CITY PLANNING COMMISSION

- APPLICATION:
- A. Negative Declaration
 - B. Variance to allow valet parking for all required parking
 - C. Variance to reduce required parking from 70 to 49 spaces
 - D. Variance to waive the required four foot on-site planter

LOCATION: 1310 Alhambra Boulevard

PROPOSAL: The applicant is requesting the necessary entitlements to allow valet parking for an existing restaurant.

EXHIBIT "A"

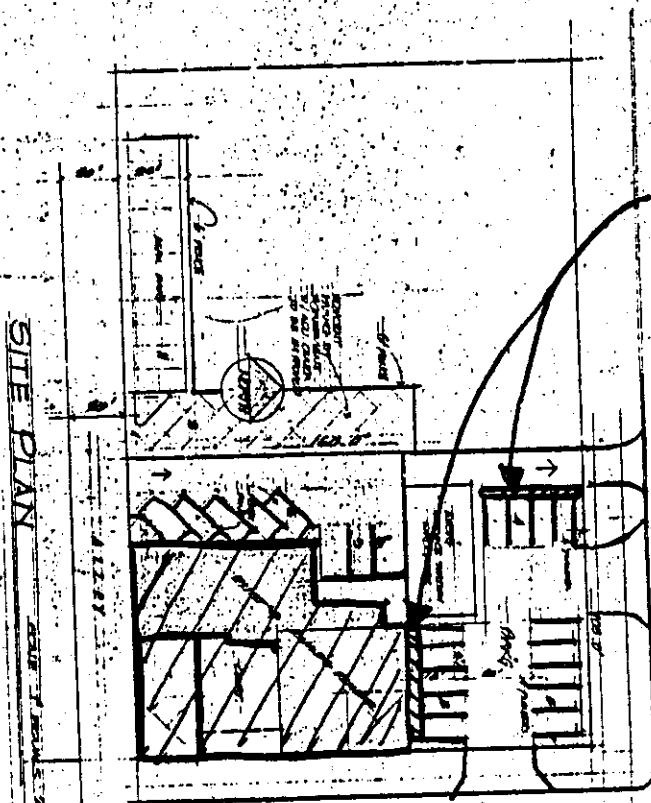
based on a 66 seat restaurant with 22 on-site parking spaces. The existing service station building and a portion of the restaurant structure was shown to be converted to office use at a future date. A condition of approval was that additional planting be provided as indicated by Exhibit A. This parking design provided from 20 to 22 parking spaces and provided the required four foot planters.
